50 THE DRIVEWAY

DESIGN PRESENTATION - REZONING APPLICATION RESUBMISSION

JANUARY 19TH 2021

MAIN CHANGES / RESPONSES TO FEEDBACK

STEP-BACKS AFTER LEVELS 6 & 7

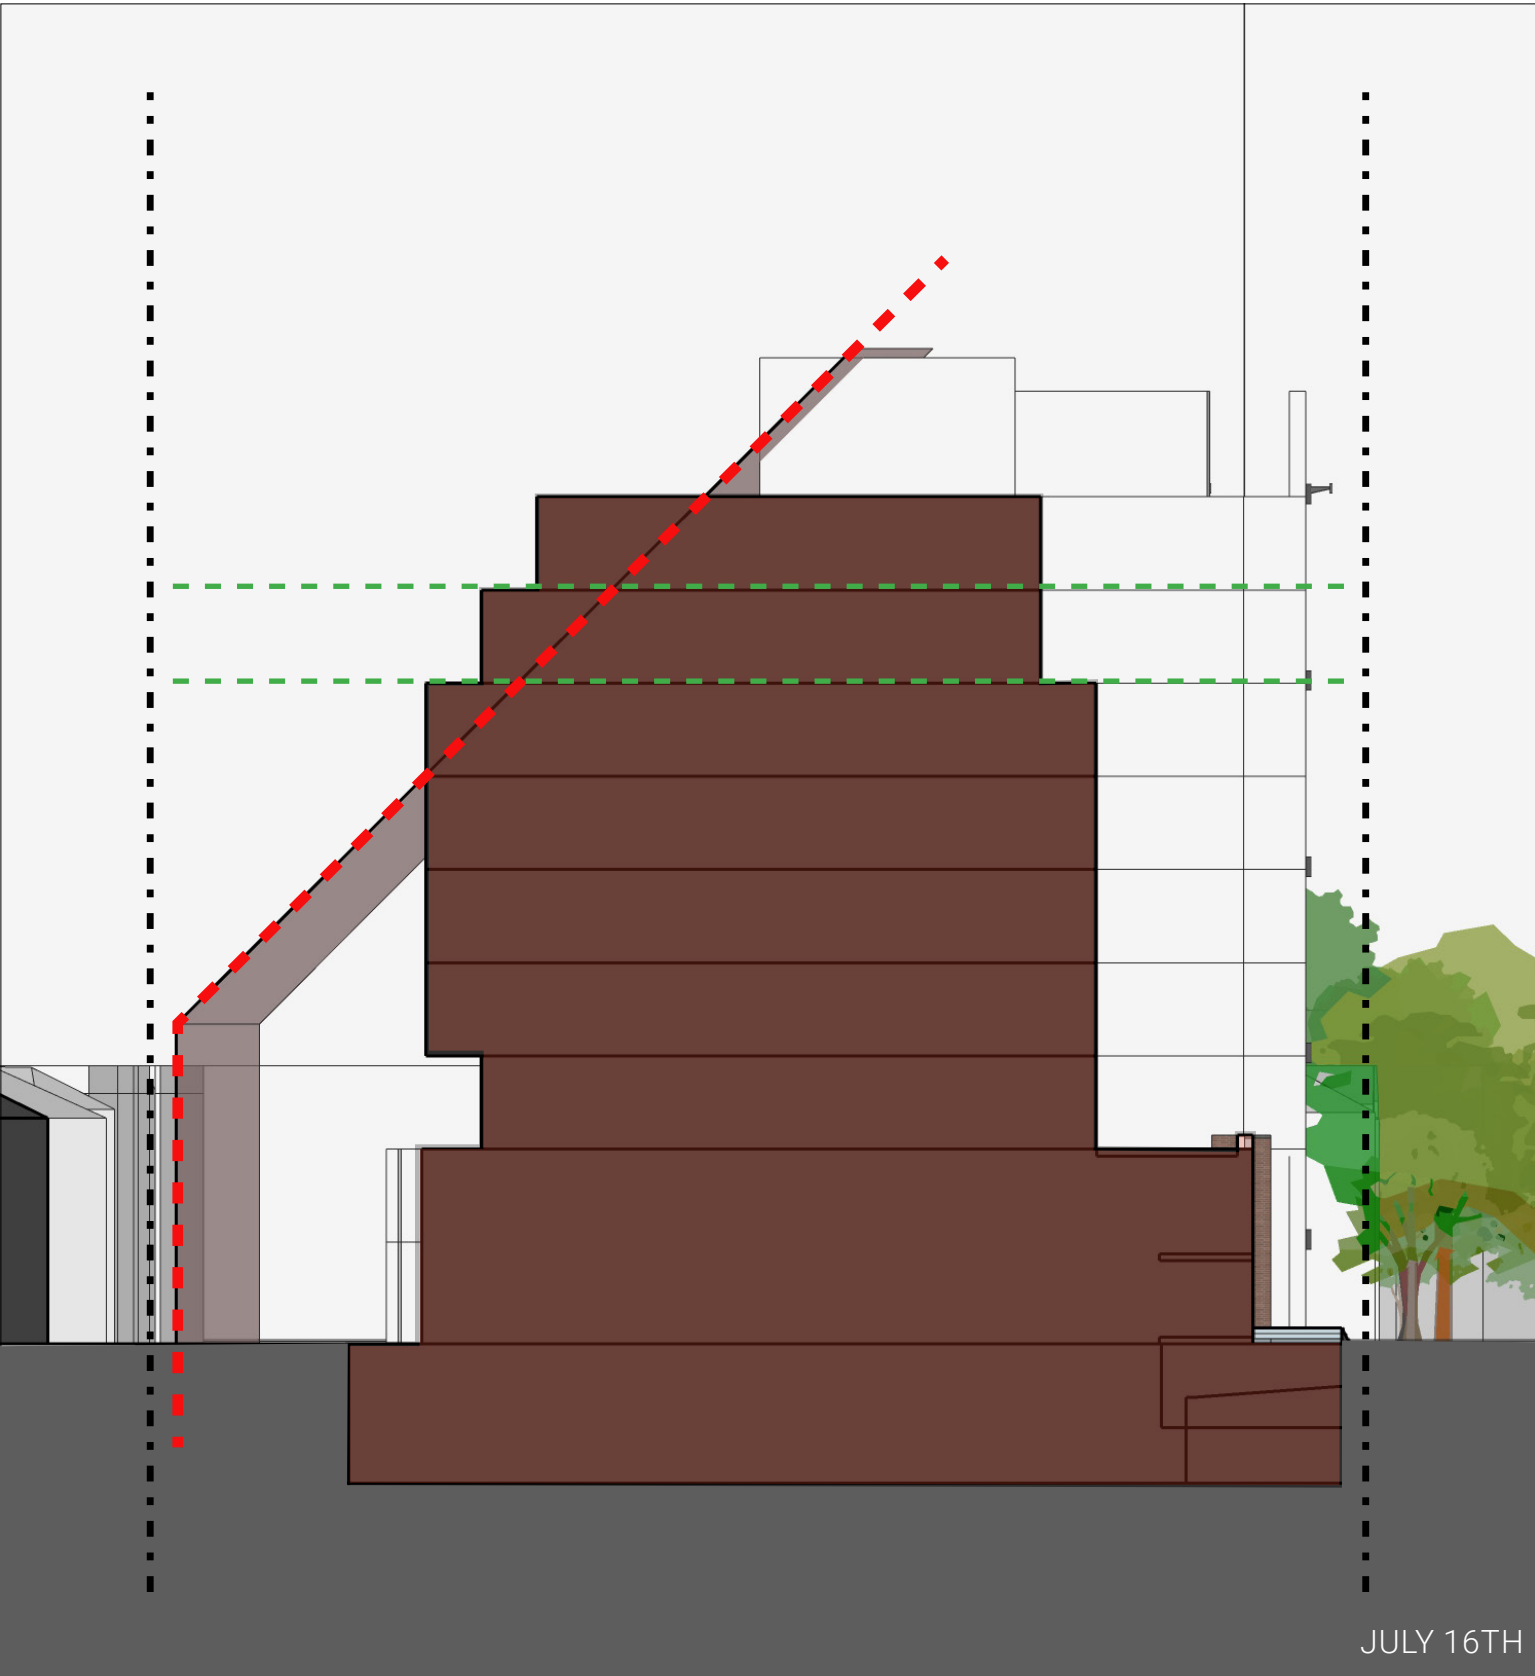
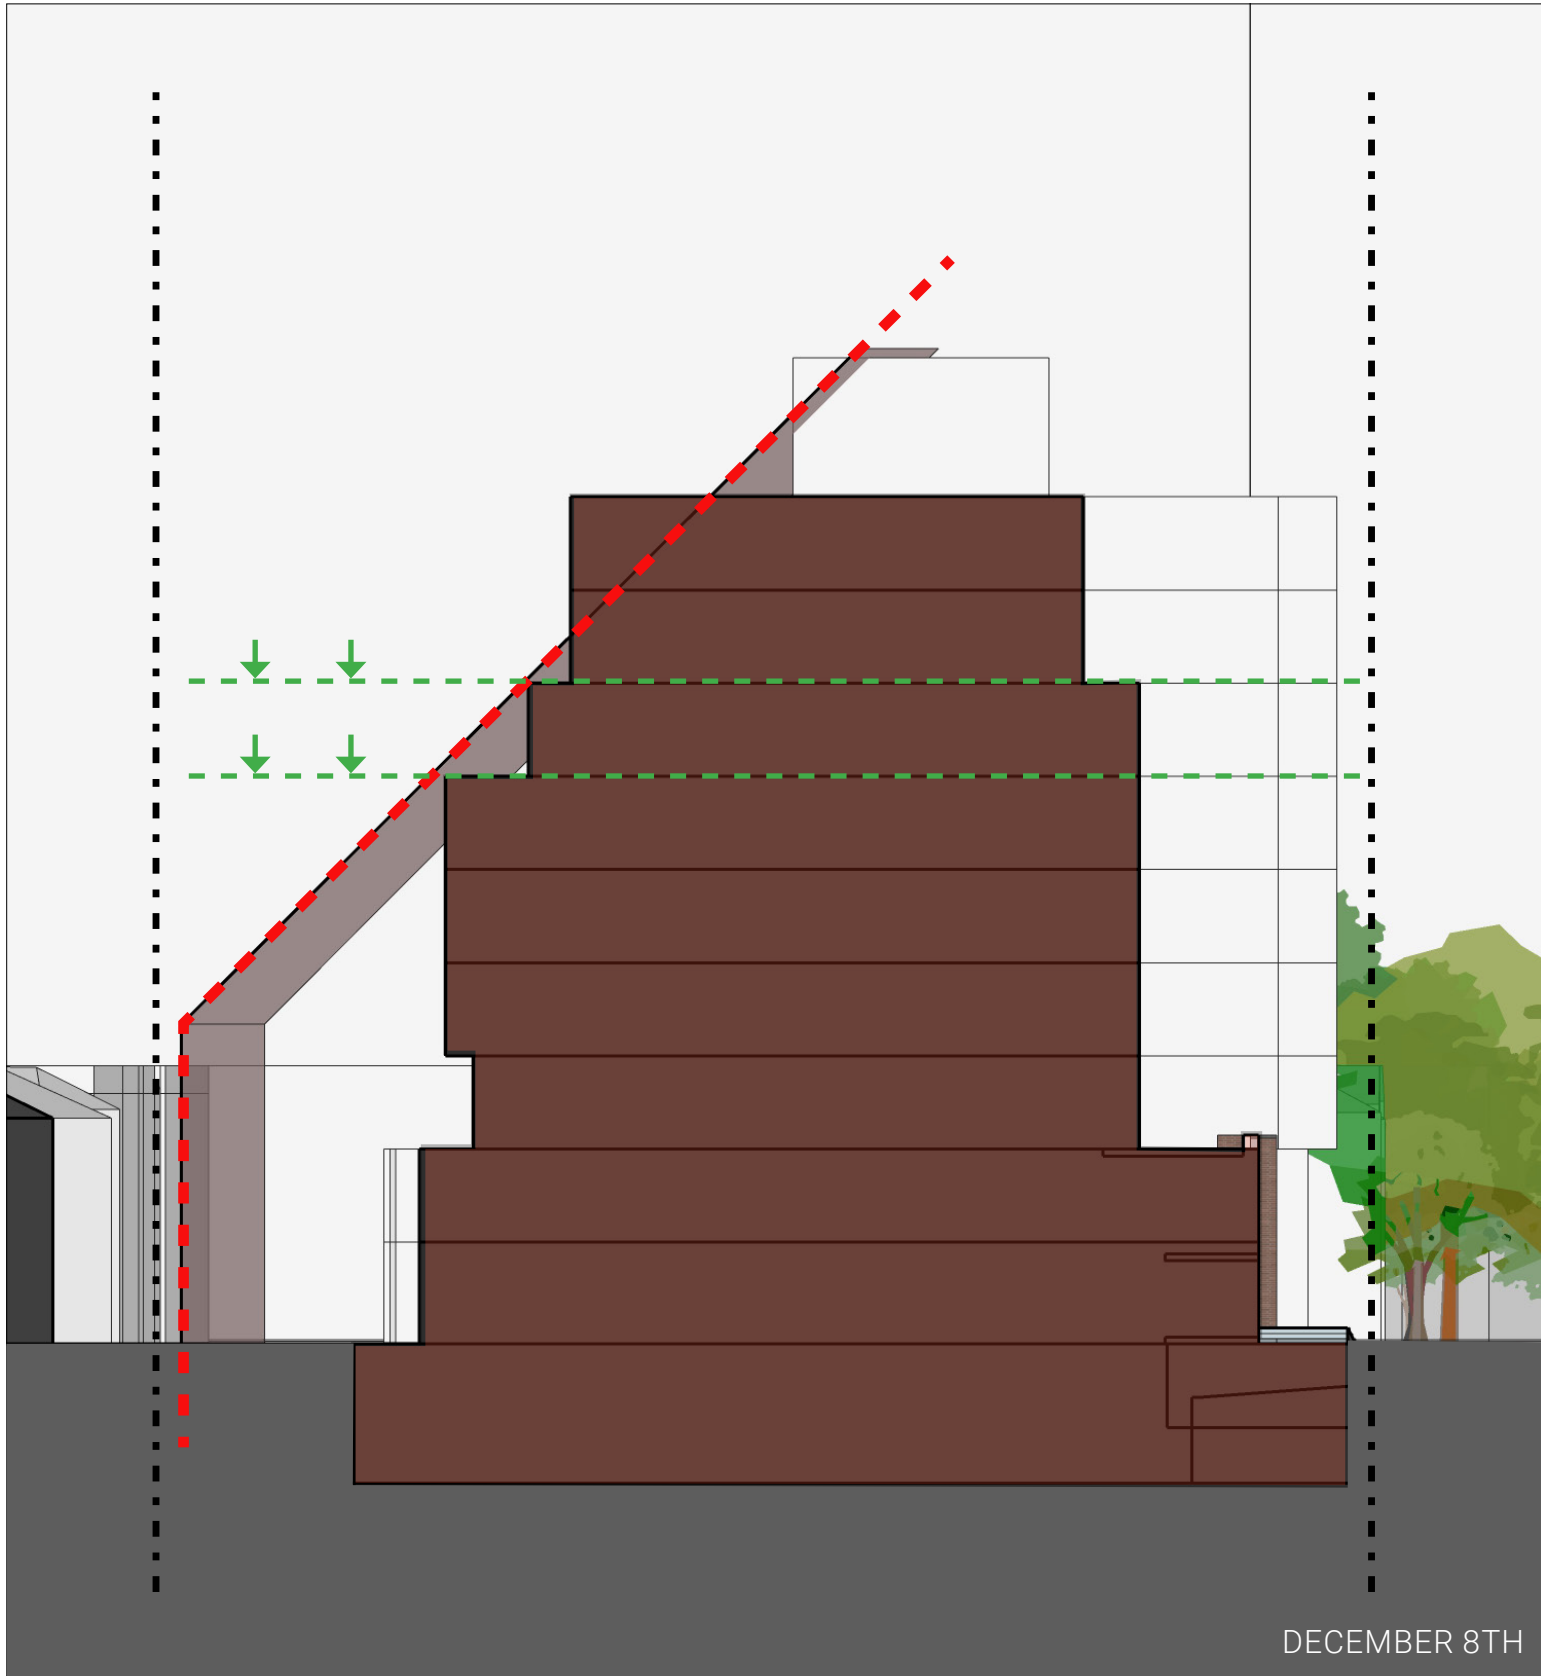
- 1- BUILDING FOOTPRINT IS PULLED BACK FROM LEWIS STREET TO RESPECT THE 3M SETBACK
 -
- 2 - ENTIRE WEST FACADE ABOVE THE PODIUM IS SHIFTED EAST BY AN ADDITIONAL 0.5M
 -
- 3 - STEP-BACKS OCCURRING 1 LEVEL EARLIER (AFTER 6TH RATHER THAN 7TH FLOOR) AND ARE PULLED FURTHER IN BY 1M TO BETTER RESPECT THE INTENT OF THE ANGULAR PLANE
 -
- 4 - EAST FACADE ABOVE HERITAGE BUILDING SHIFTED EAST BY 1M & HERITAGE PULLED CLOSER TO PROPERTY LINE BY 0.3M (RESPECTING THE 1.2M SIDE YARD SETBACK)

NEW PROPOSED STEP-BACK PROFILE

ANGULAR PLANE COMPARISON - **JANUARY 19TH**

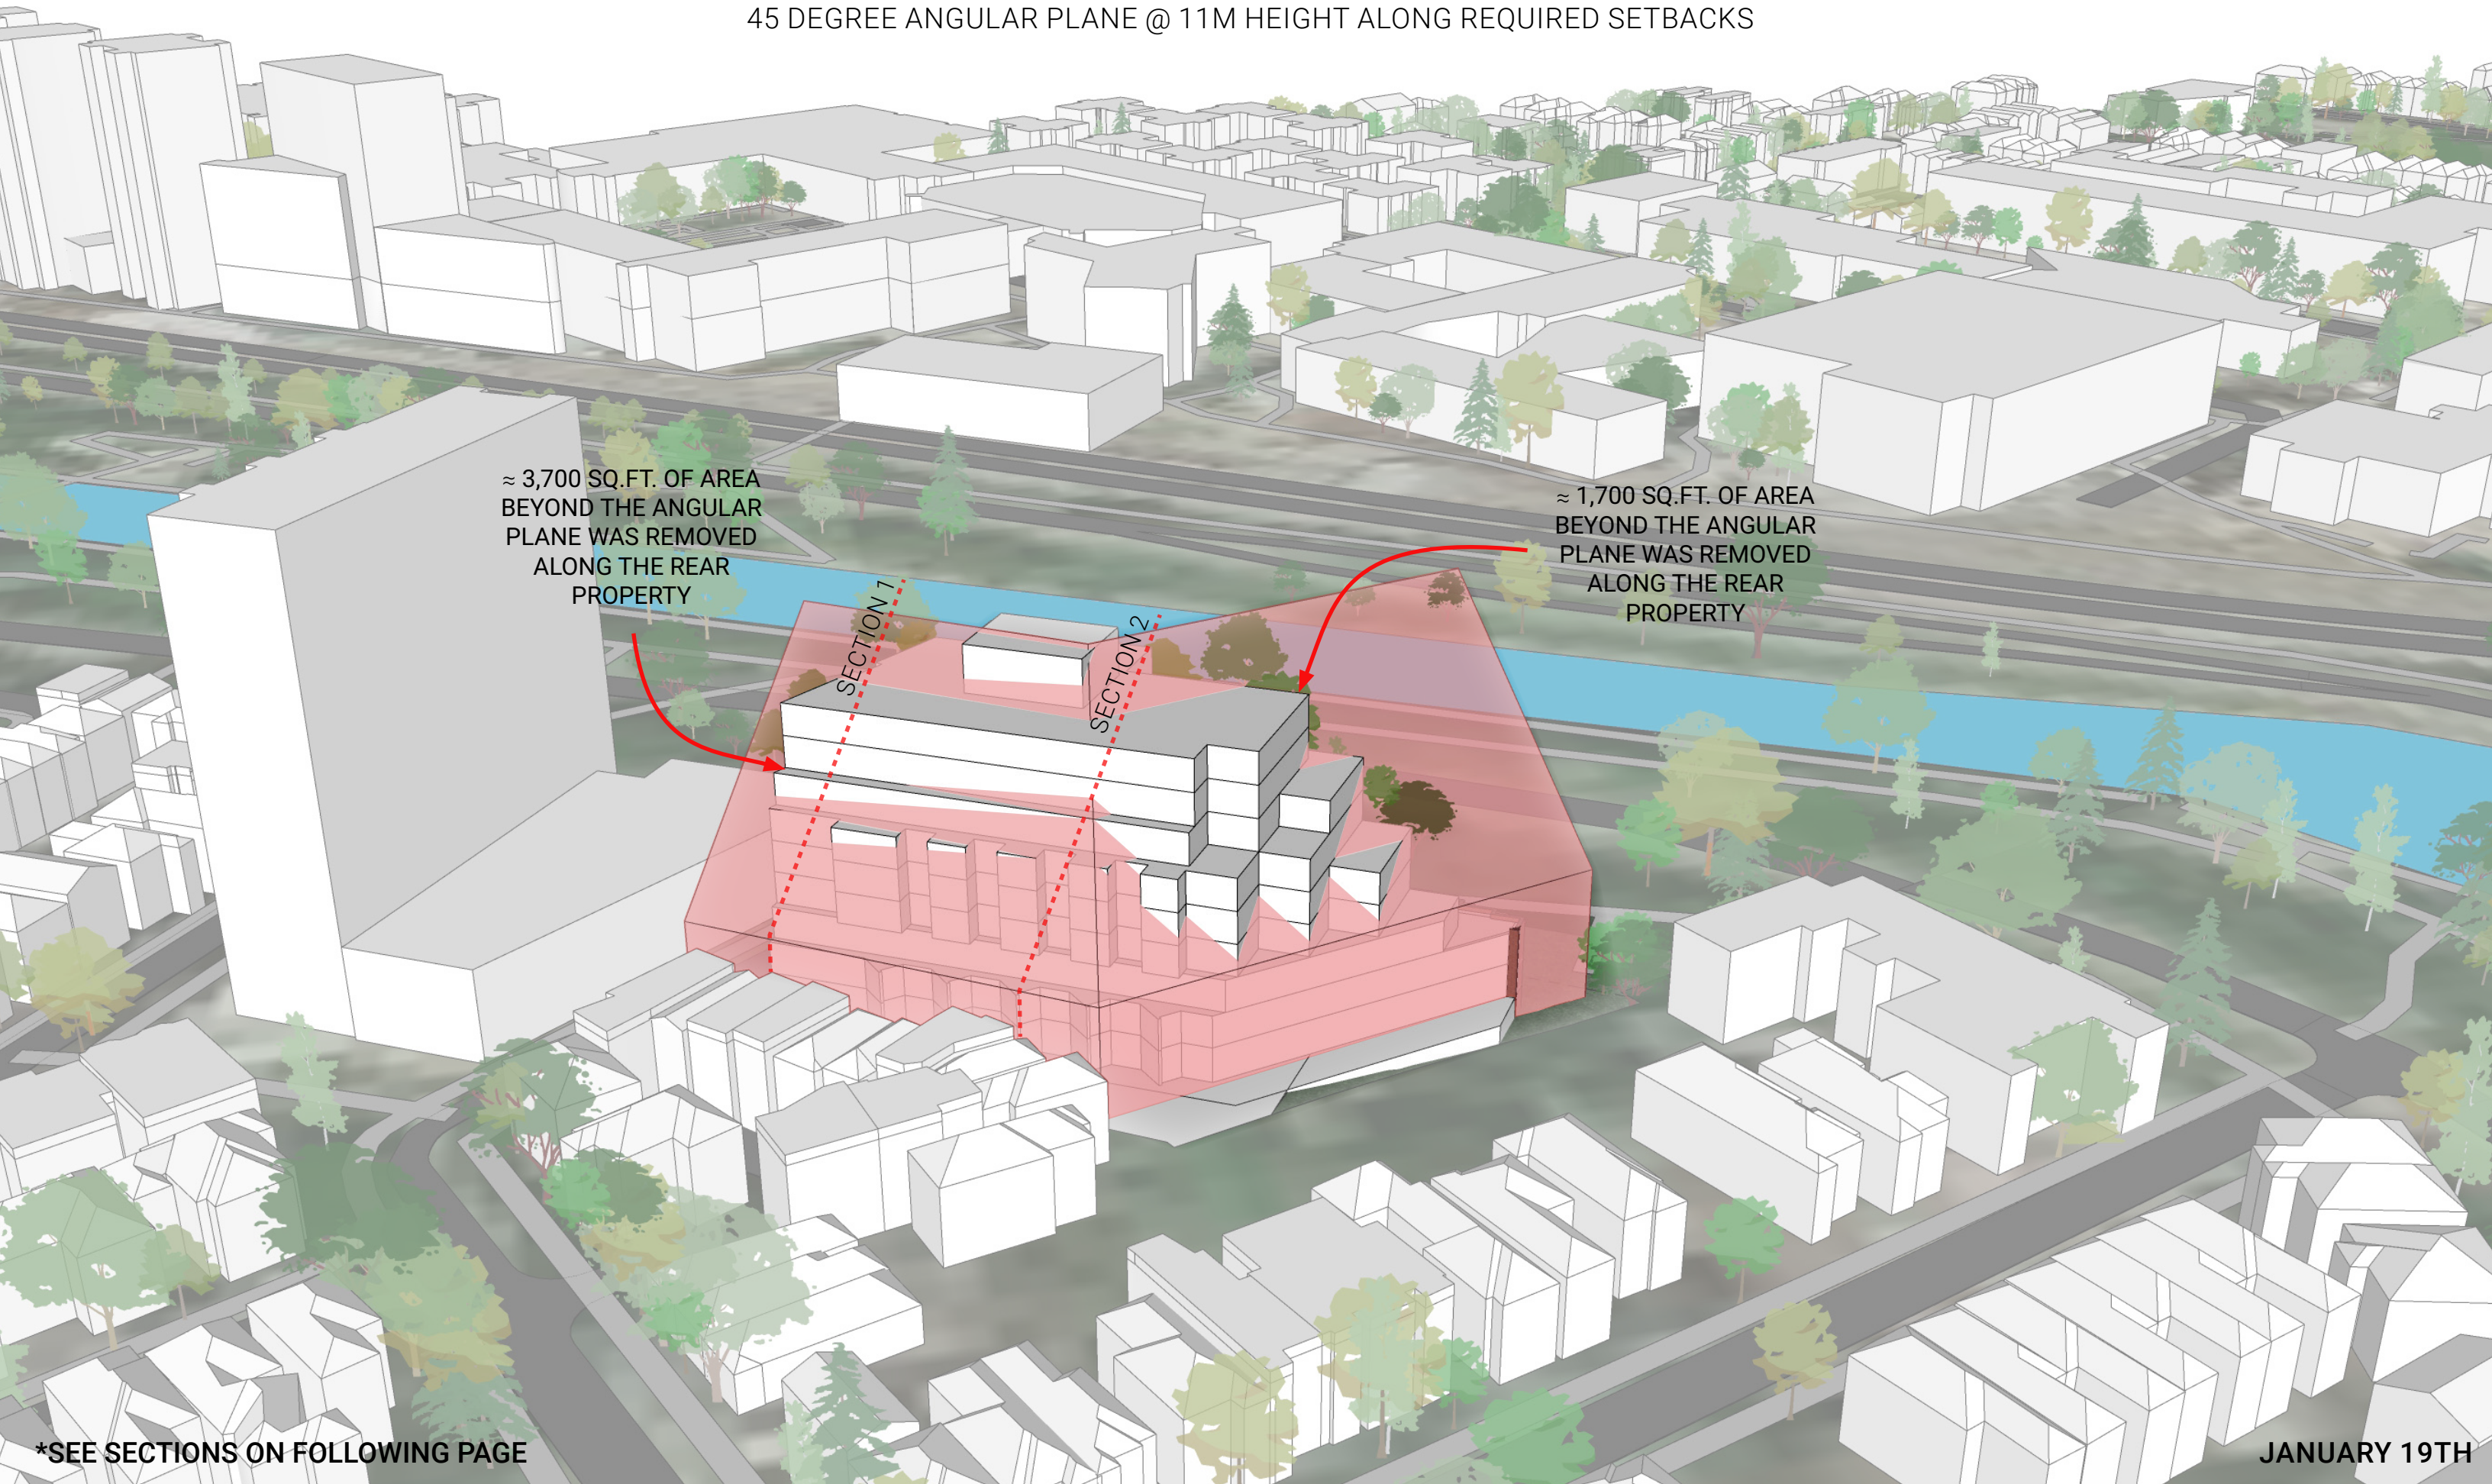
≈ 3,700 SQ.FT. OF AREA
BEYOND THE ANGULAR
PLANE WAS REMOVED
ALONG THE REAR
PROPERTY

≈ 1,700 SQ.FT. OF AREA
BEYOND THE ANGULAR
PLANE WAS REMOVED
ALONG THE REAR
PROPERTY

DESIGN EXPRESSION:

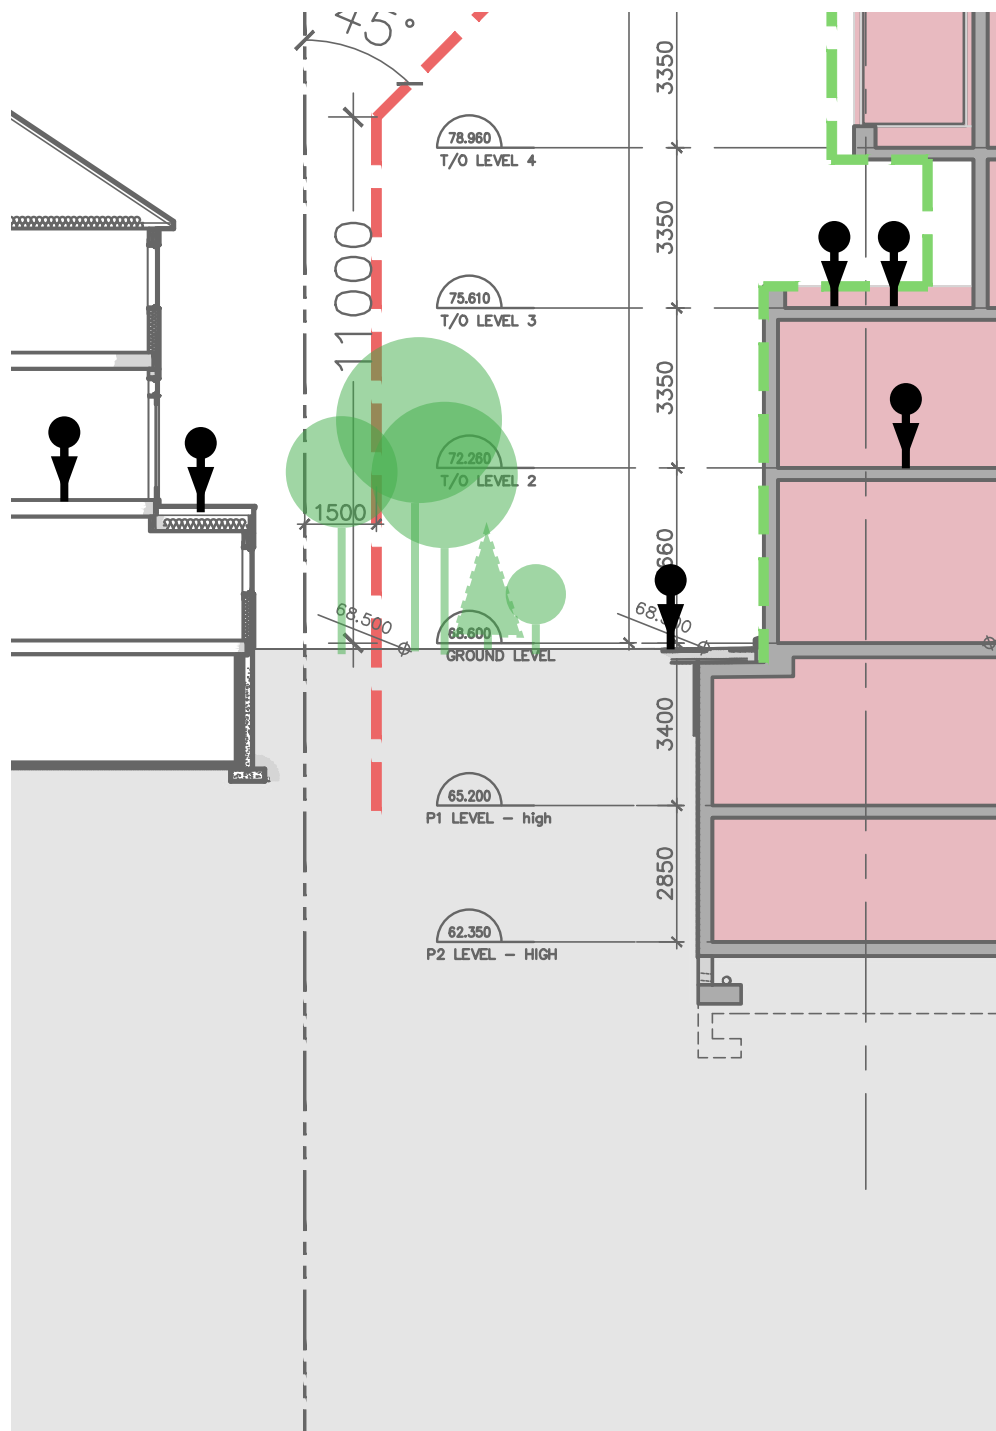
- 1 - MITIGATION OF OVERLOOK THROUGH DESIGN INTERVENTIONS ALONG WEST FACADE
 -
- 2 - NEW POSITIONING OF THE LANTERN; THIS FEATURE IS TO BE INTEGRATED WITH THE DESIGN AS A ROOF ELEMENT
 -
- 3 - VERTICAL CORNER EXPRESSION IS BEING REDUCED, DESIGN IN PROGRESS
 -
- 4 - DESIGN/MATERIALITY OF BASE WILL BE REVISITED; DESIGN IN PROGRESS
